**Request for Additional Information No. 20, Revision 0**

**7/28/2008**

**U.S. EPR Standard Design Certification**

**SRP Section: 09.05.01 - Fire Protection Program**

09.05.01-9 → **Figure 9.5.1-1—Fire Water Distribution System  
Sheet 3 of 13**

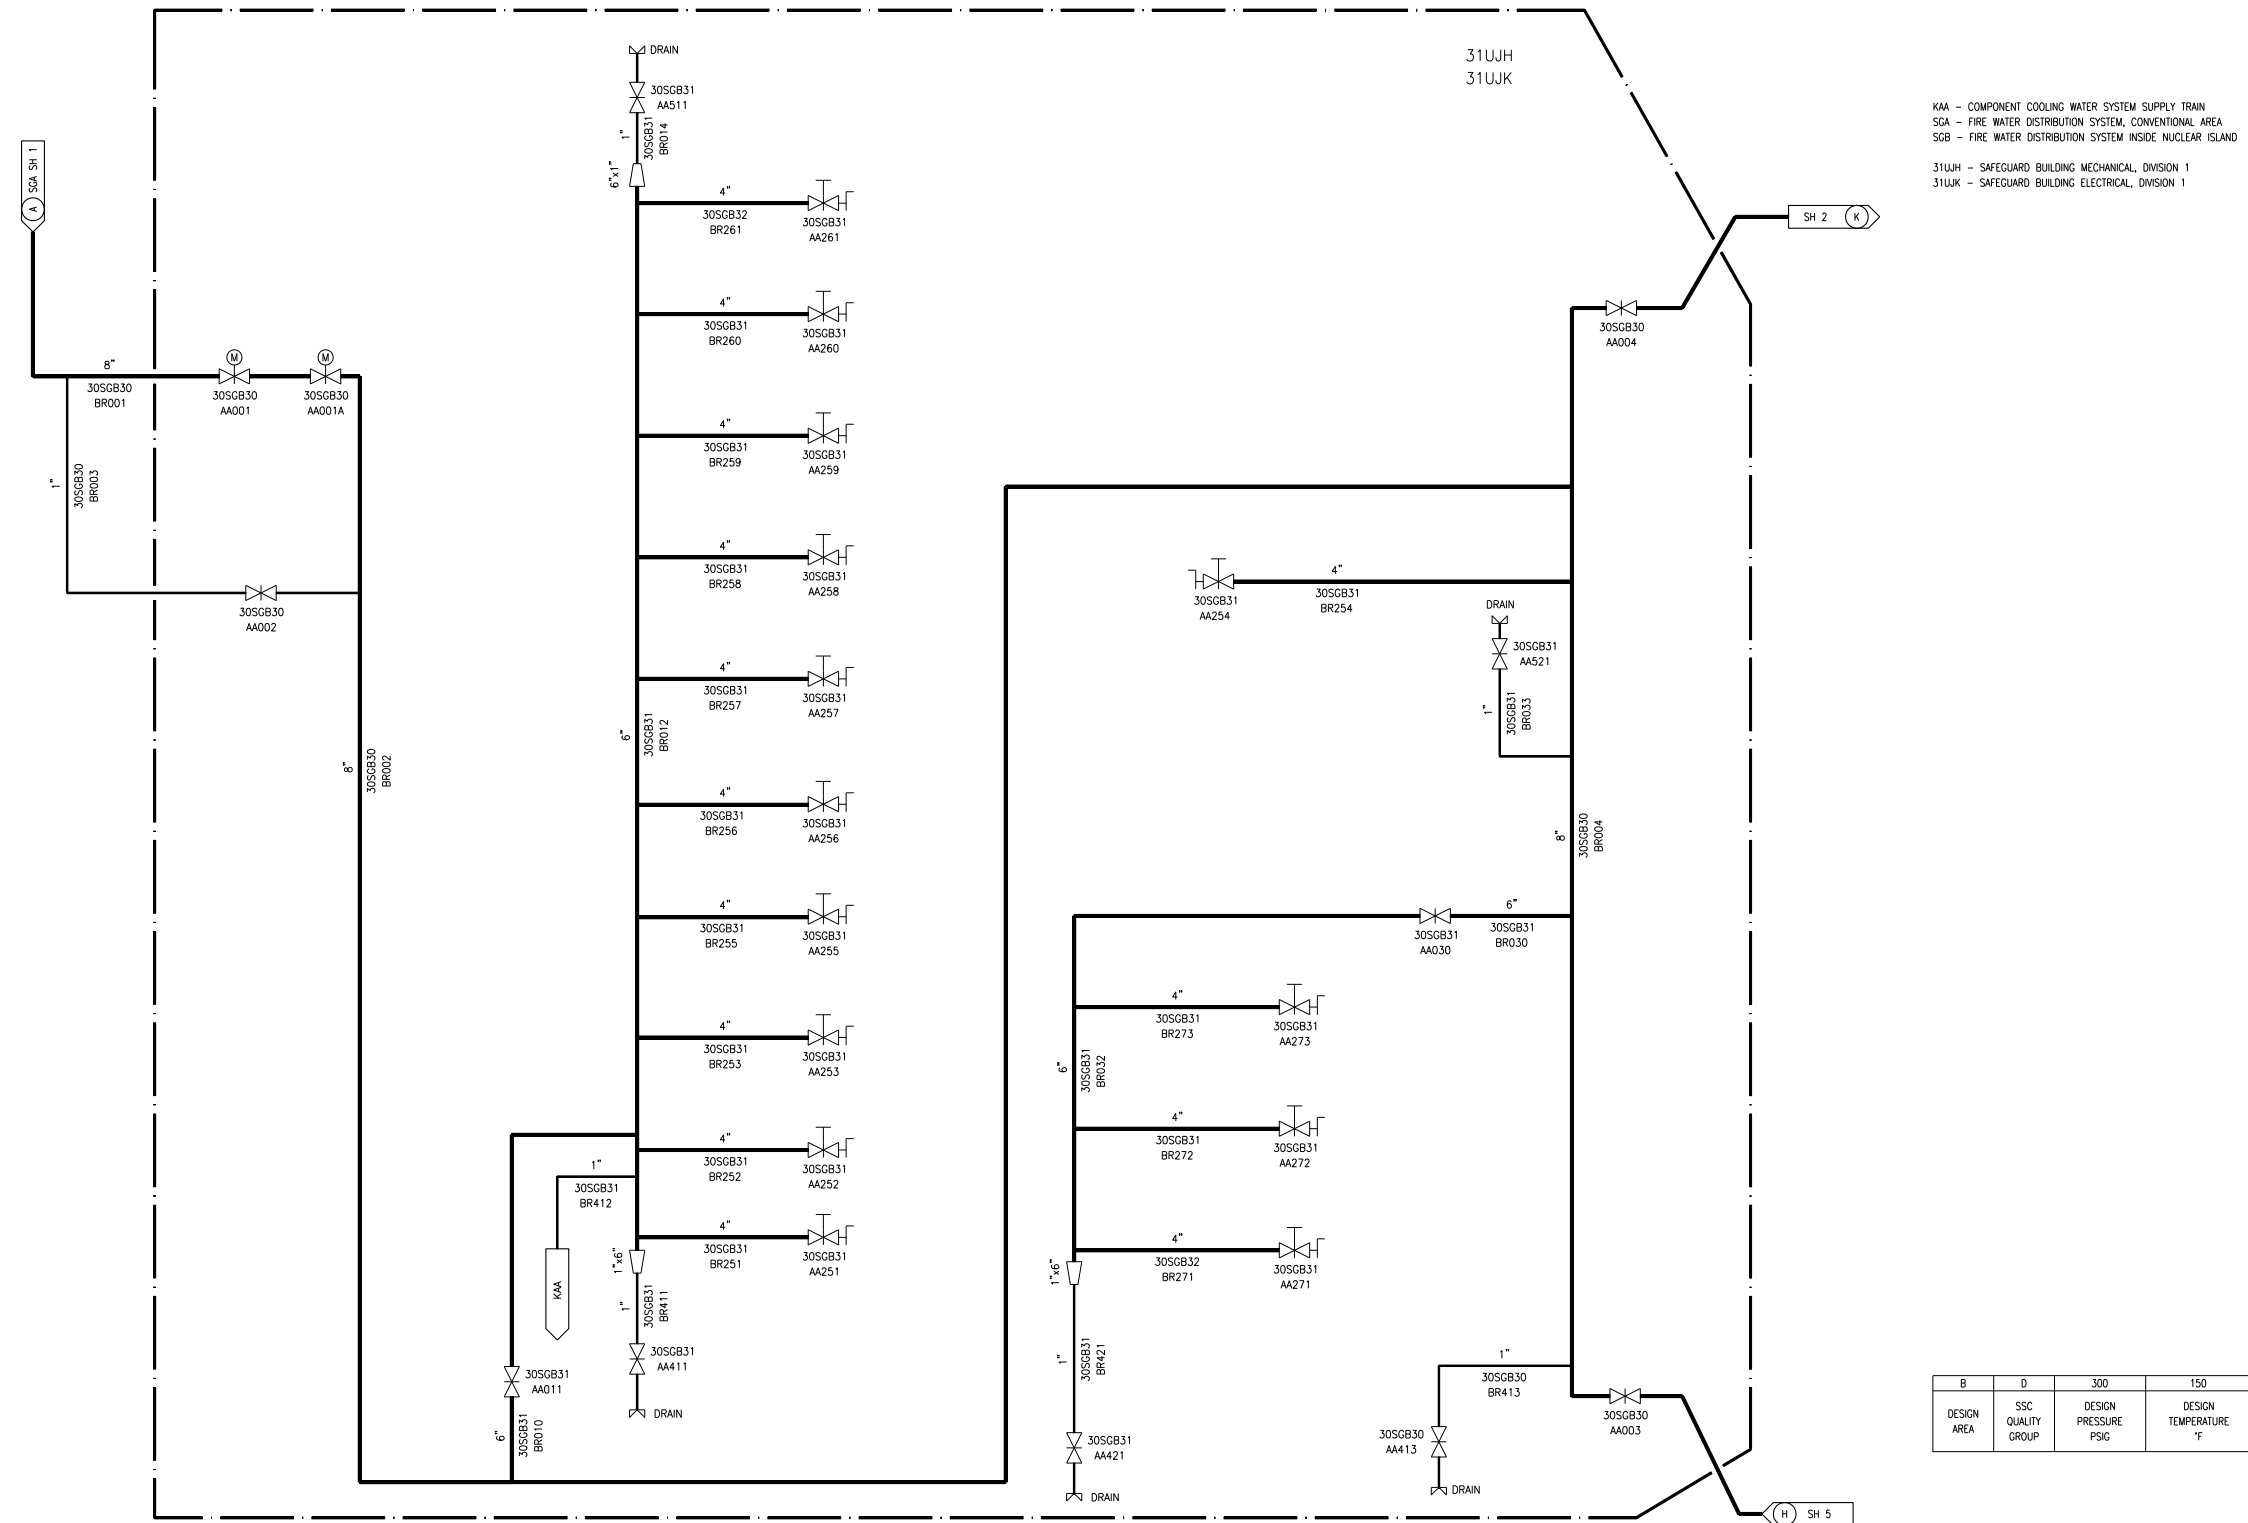
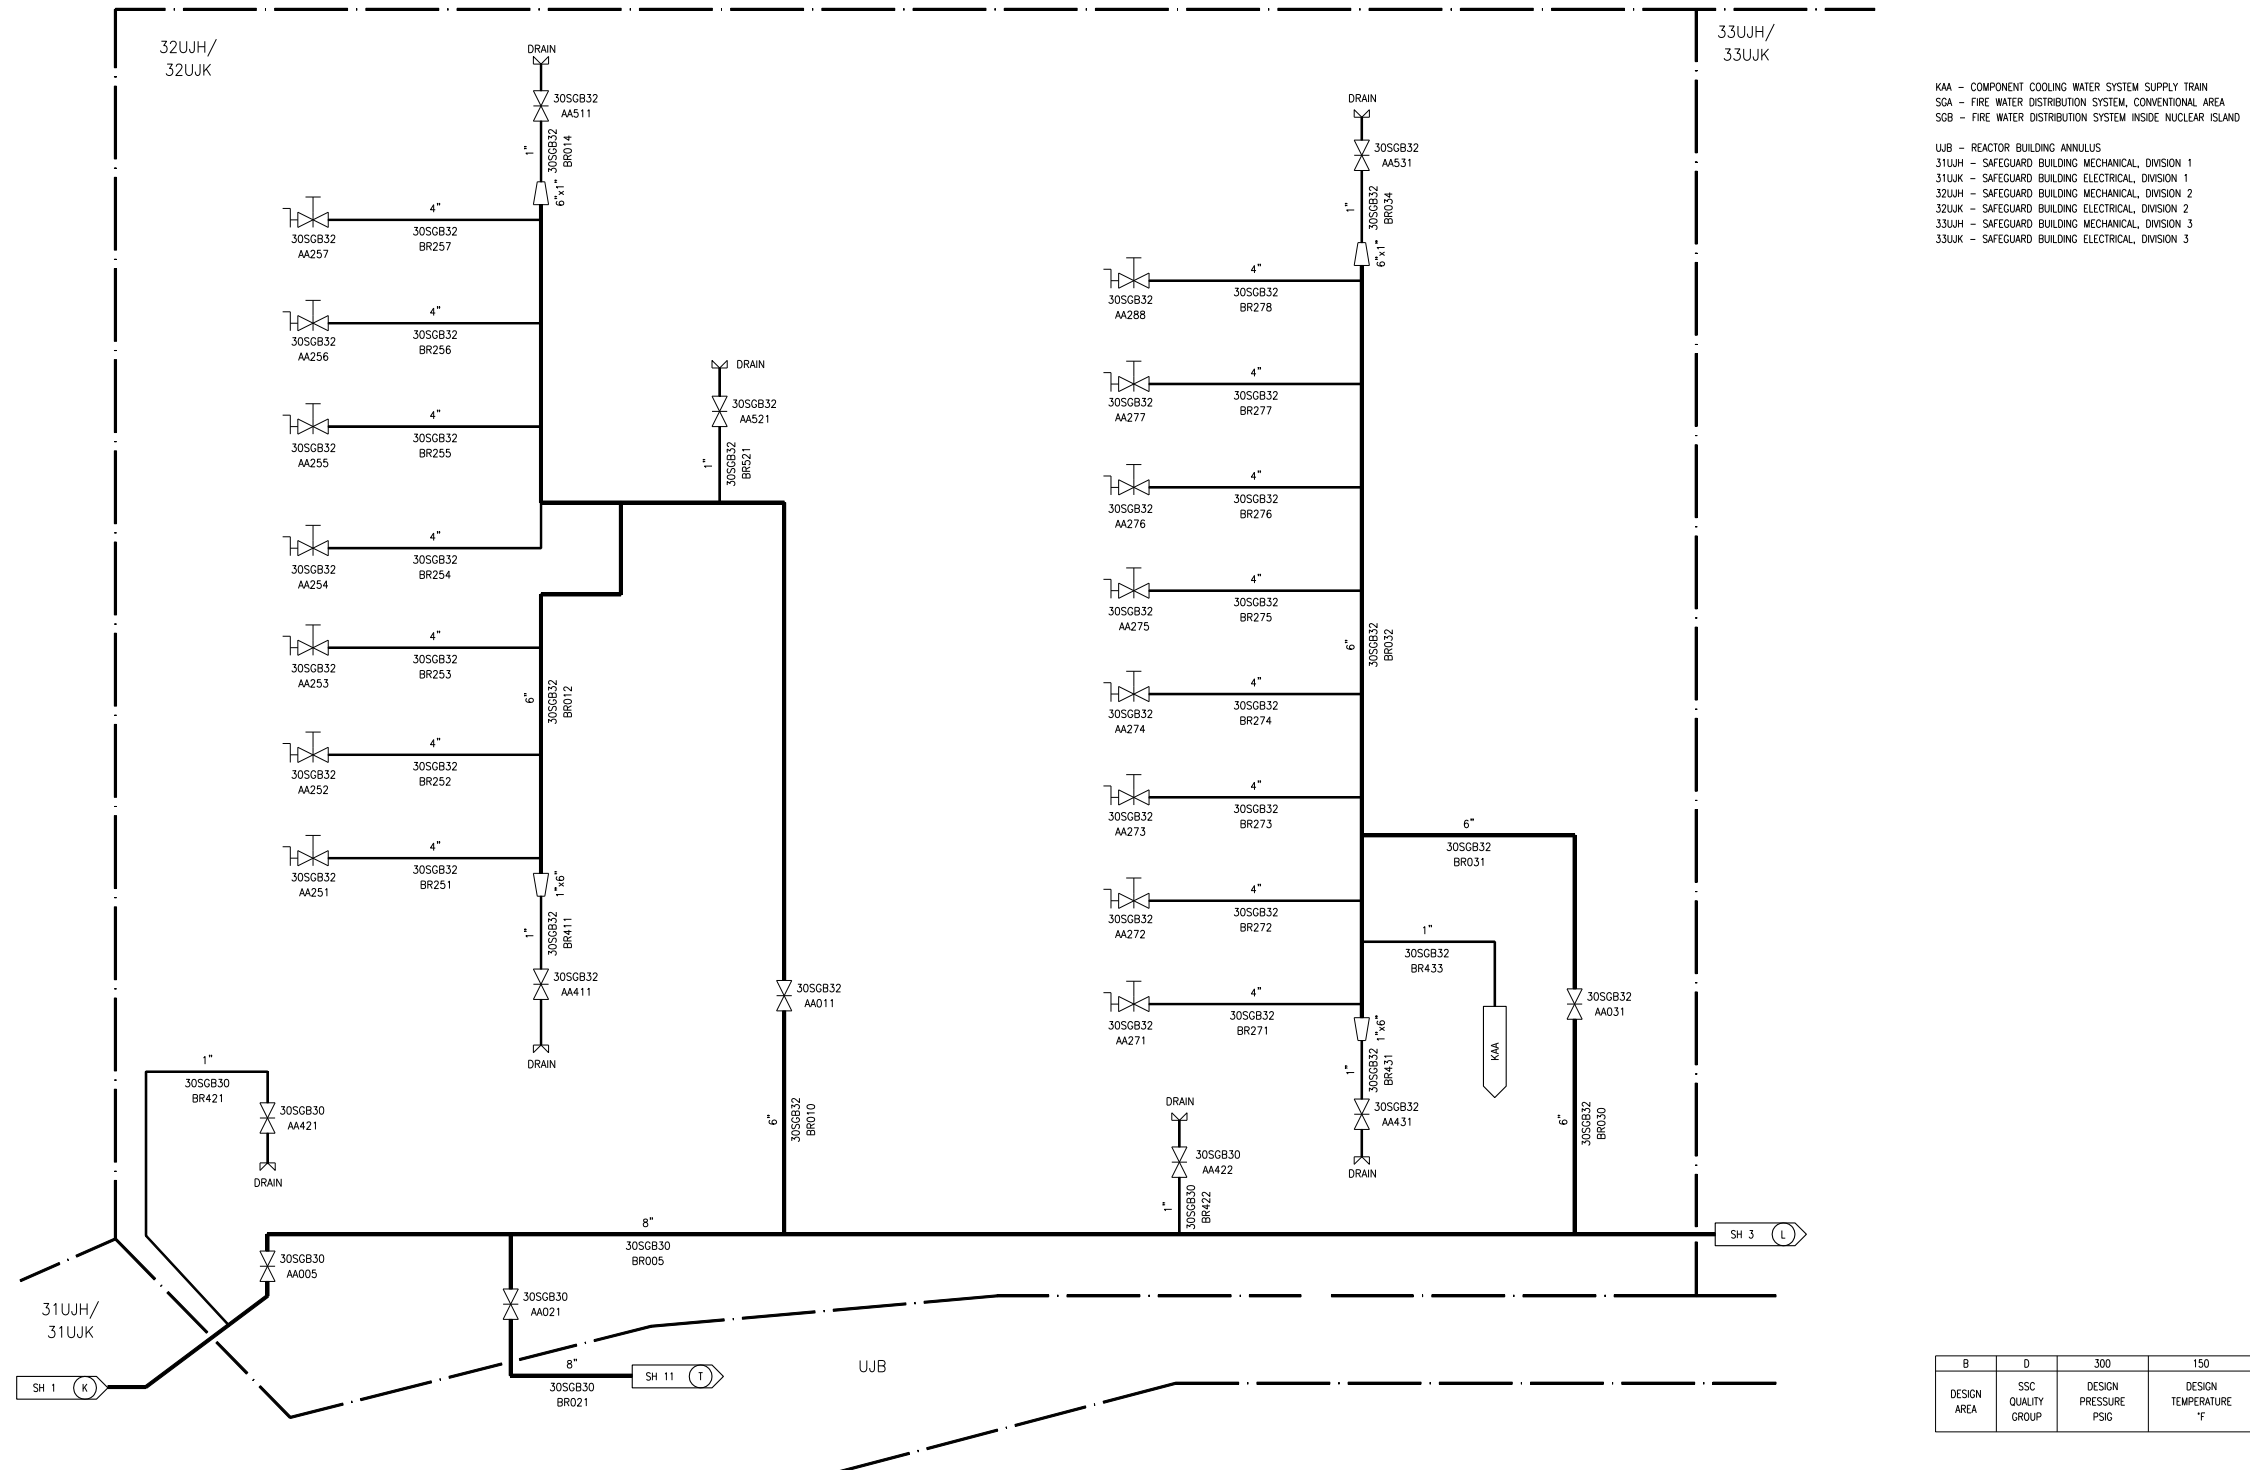
The EPR FSAR should add a COL information item to provide simplified FPS piping and instrumentation diagrams showing complete site-specific systems. Nuclear Island definition is different in Figure 9.5.1-1 then in Tier 1 Section 2.1.1. Modify FSAR accordingly. Basis: Completeness of application.

U.S. EPR FSAR Tier 2, Figure 9.5.1-1 depicts the fire water distribution system for the Nuclear Island (NI) and plant areas not considered part of the NI. However, the current title for this figure is "Fire Water Distribution System Inside Nuclear Island."

The title for U.S. EPR FSAR Tier 2, Figure 9.5.1-1 will be changed to "Fire Water Distribution System." The reference to this figure in U.S. EPR FSAR Tier 2, Section 9.5.1.2.1, under "Fire Water Supply System," will be revised to reflect the new title identified above.

U.S. EPR FSAR Tier 2, Section 9.5.1.2.1 will be revised as described in the response and indicated on the enclosed markup. U.S. EPR FSAR Tier 2, Figure 9.5.1-1 will be revised as described in the response and indicated on the enclosed markup. U.S. EPR FSAR Tier 2, Table 1.8-2 will be revised as described in the response and indicated on the enclosed markup.
